Planning Inspectorate Examination EN010137: Mona Offshore Wind

Cefn Meiriadog Community Council MNOW-ISP002

Deadline 5, 3 December 2024

Response of the Community Council to the Applicant's Change Request Application

Figure 2: Passing Locations

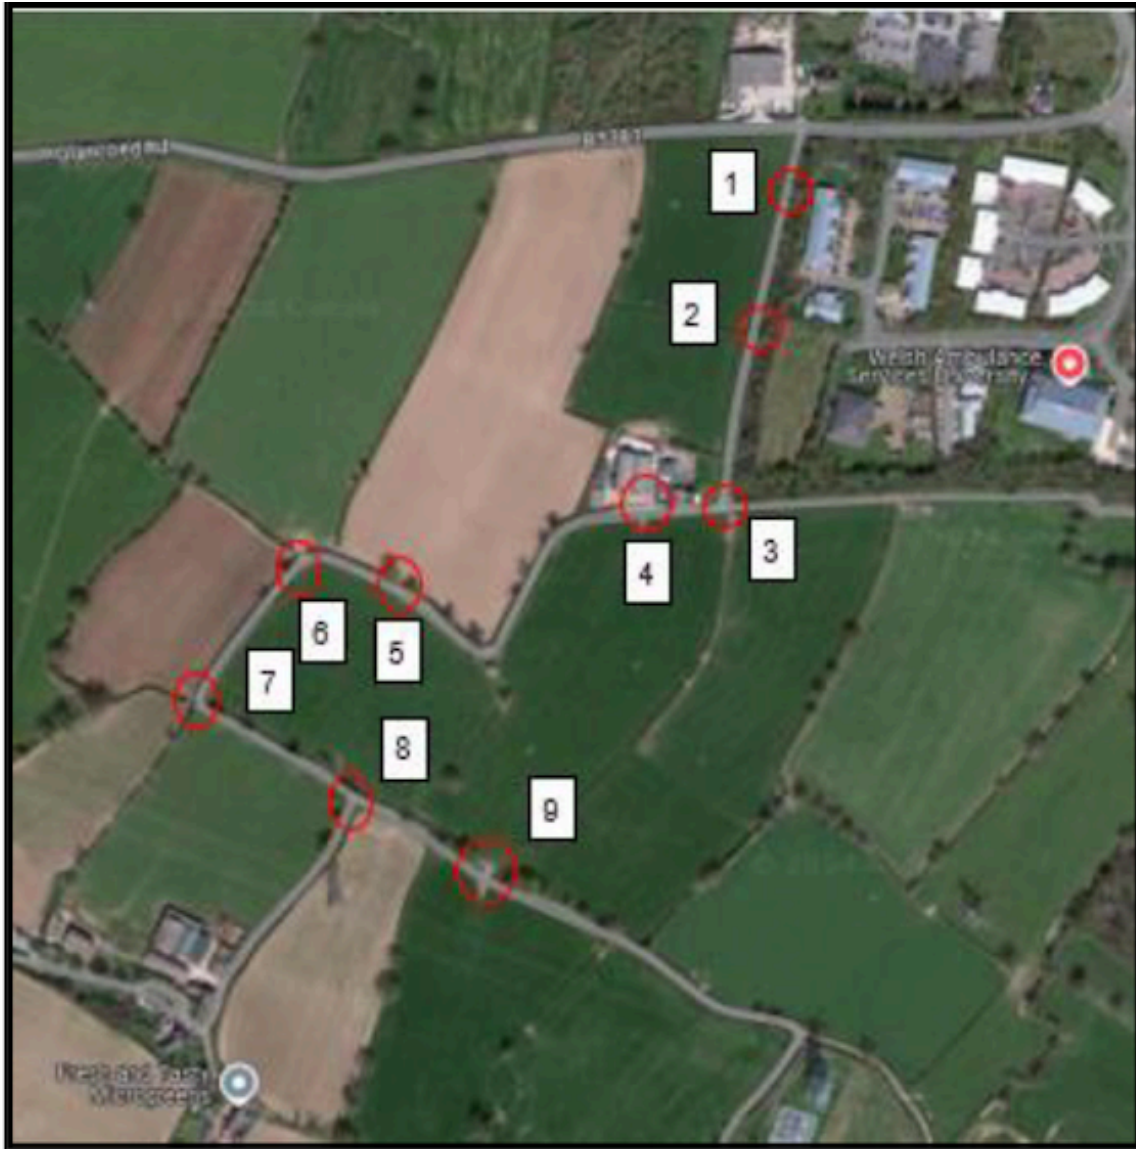
16. **Passing Places.** The availability of passing places on a road of this nature is critical. The Appendix (1.2.2.3) states that there are “approximately nine”, as per the Applicant’s own Figure 2 reproduced here.

As is shown below, this is grossly misleading, and it can only be assumed that it was produced from a desk-top exercise rather than any site visit or familiarity with the actual road itself. It will be noted that only three of the “Passing Points” identified by the Applicant are within that section of road where the ninety-degree bends have to be negotiated, and one of these (“Passing Point 7”) cannot realistically be taken into consideration. Below are photographs of each of the nine locations shown in the Applicant’s Figure 2. It hardly seems necessary to further point out the limitations of these “Passing Points”, but perhaps 7 and 9 merit particular attention. (It is acknowledged that these photographs were taken in particularly inclement weather conditions due to the necessity to meet the ExA’s Deadline 5)
